Office Action Summary	Application No. 10/566,869	Applicant(s) NAGAI ET AL.	
	Examiner Thomas Diaz	Art Unit 4171

DETAILED ACTION

10. Claims 1-4, as best understood, are rejected under 35 U.S.C. 102(b), as best understood, as being anticipated by Huetsch (U.S. Patent 4,685,861).

FIG. 1

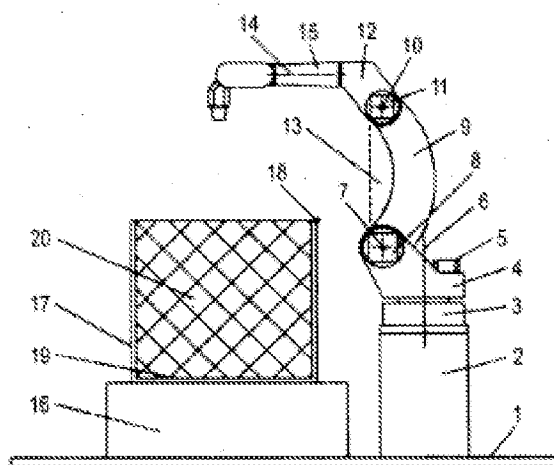
11. Applicant claims an industrial robotic arm as which is represented by Figure 1 below.

The applicant further claims that the first arm has a continuous-curved C shape, wherein the thickness of said C-shaped first arm decreases continuously from the swing part to a second arm drive part.

15. Regarding claims 3 and 4, applicant further claims that the center of gravity of the first arm is offset from the line connecting the rotating axes 8 and 10 due to said first arm having curvature as depicted in applicant's figure. Since the shape of the prior art structure is substantially the same as the applicant's embodiment shown by Figure 1, the center of gravity will be inherently offset as claimed.

FIG. 1

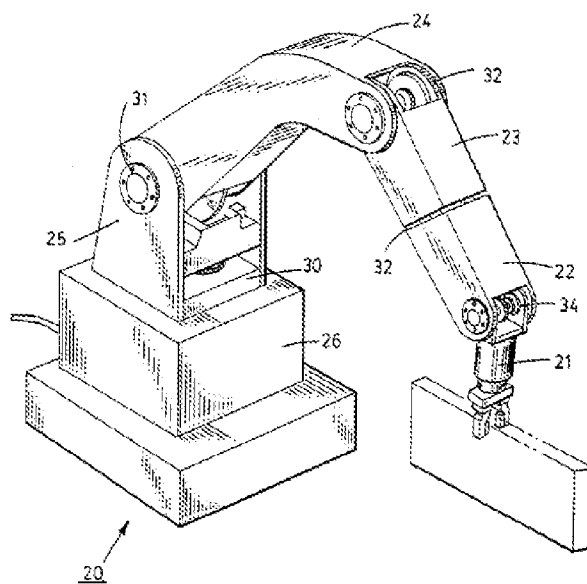
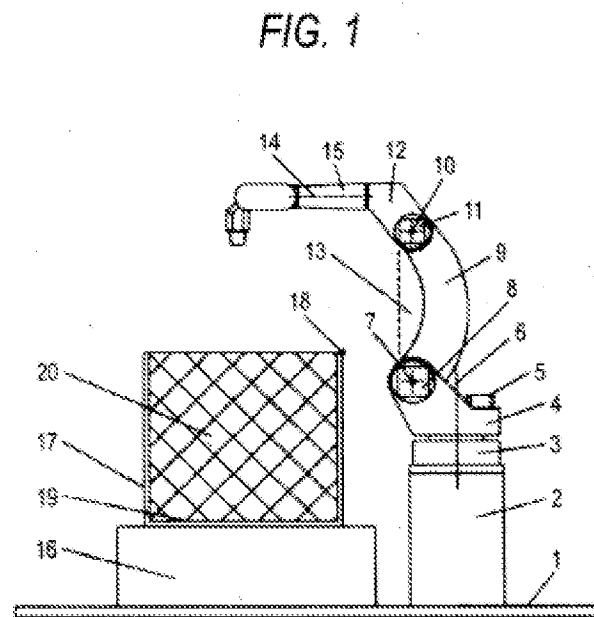
12. Huetsch teaches a robotic arm as shown below.

Claimed Limitations	Applicant's Ref. #	Huetsch's Ref. #
a base	3	26
a swing part	4	25
a first ("curved") arm	9	24
a second arm	12	23

As seen in the figure above, Huetsch teaches the first arm (fig.1, 24) having a continuously-curved C shape since it has a continuously-curved C shape portion (there is a c-shaped portion at the bend in the arm 24. There are two, in fact, one on the inner part of the arm 24, and another on the outer part of the arm 24). In addition the arm decreases continuously in thickness from the swing part (fig.1, 25) to a second arm drive part (fig.1, 32).

Fig.2

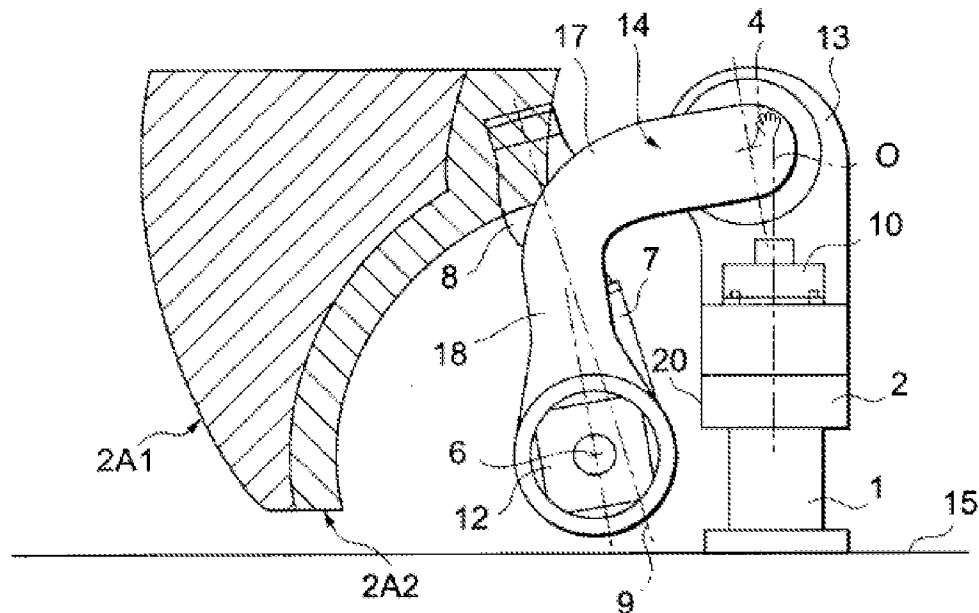
18. Murata et al. teach a robotic arm as shown below in Figure 2.

Claimed Limitations	Applicant's Ref #	Murata et al.'s Ref #
a base	3	2
a swing part	4	13
a first ("curved") arm	9	14
a second arm	12	7

As seen in the figure above, Murata et al. teaches the first arm (fig.2, 14) has a continuously-curved C shape since it has a continuously-curved portion (fig.2, 17). Furthermore, a thickness of the first arm decreases continuously from one end connected to a second arm drive part (fig.2, 12) to the swing part (fig.2, 13).

FIG. 2

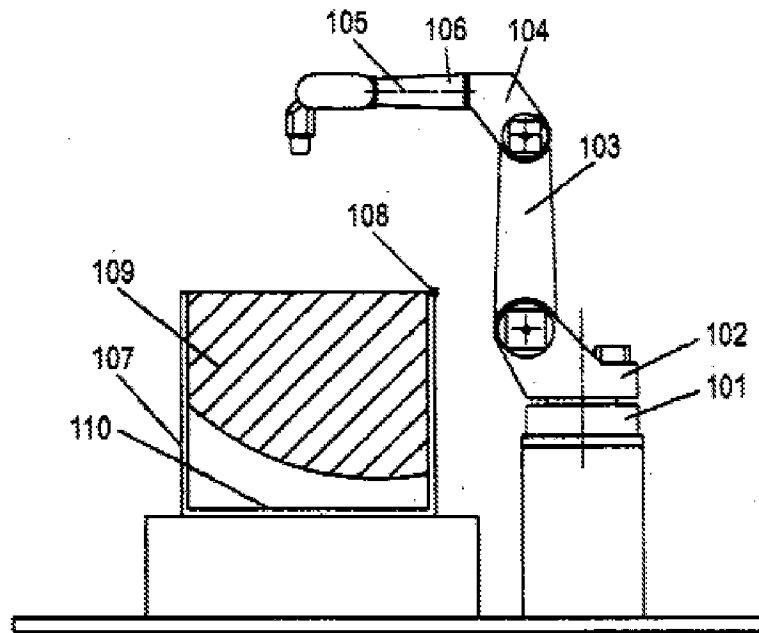
1. The drawings are objected to because figures 2 and 3 should be labeled with the label -prior art-. Examiner recommends changing the label from related art to prior art for consistency with the MPEP. Corrected drawing sheets in compliance with 37 CFR 1.121(d) are required in reply to the Office action to avoid abandonment of the application. Any amended replacement drawing sheet should include all of the figures appearing on the immediate prior version of the sheet, even if only one figure is being amended. The figure or figure number of an amended drawing should not be labeled as "amended." If a drawing figure is to be canceled, the appropriate figure must be removed from the replacement sheet, and where necessary, the remaining figures must be renumbered and appropriate changes made to the brief description of the several views of the drawings for consistency. Additional replacement sheets may be necessary to show the renumbering of the remaining figures. Each drawing sheet submitted after the filing date of an application must be labeled in the top margin as either "Replacement Sheet" or "New Sheet" pursuant to 37 CFR 1.121(d). If the changes are not accepted by the examiner, the applicant will be notified and informed of any required corrective action in the next Office action. The objection to the drawings will not be held in abeyance.

The APA teaches a similar industrial robot as seen in the figure below:

Above figure- APA robot.

The APA does not disclose the arm 103 having a continuous-curved C shape.

【図1】

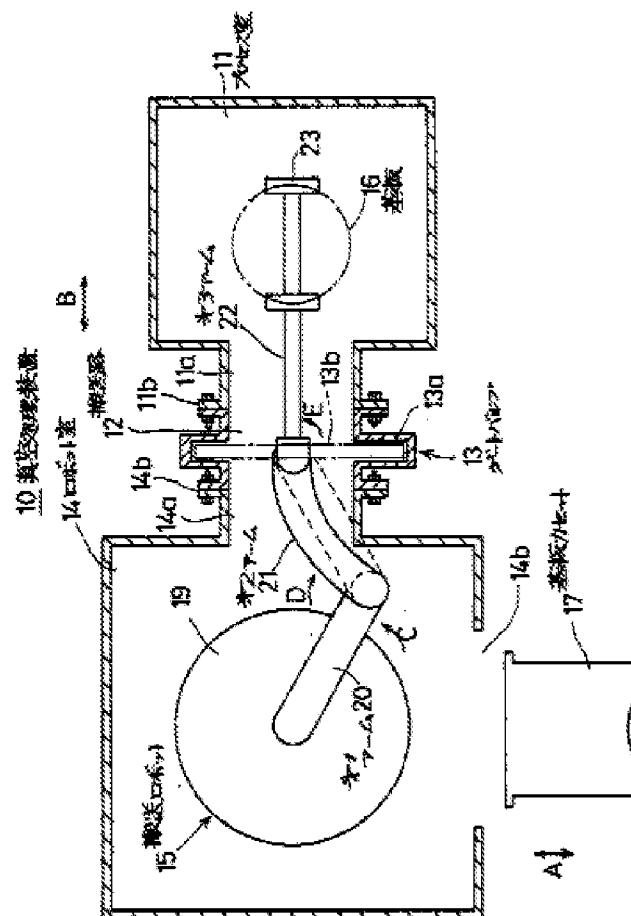
Nakamura teaches a robot having an arm which has a continuous-curved C shape (fig.1, 21) for the purpose of preventing interference with conveyance passage and also allows for a reduction in size of the work conveyance passage and reduction in the arm operation range (see abstract provided).

Examiner notes that although Nakamura does not explicitly disclose a thickness of the arm decreasing from one end to the other end, it would be an obvious modification at the time of the invention to optimize the thickness of the arm in order to maximize the amount of interference prevented.

Above figure- Nakamura's robot.
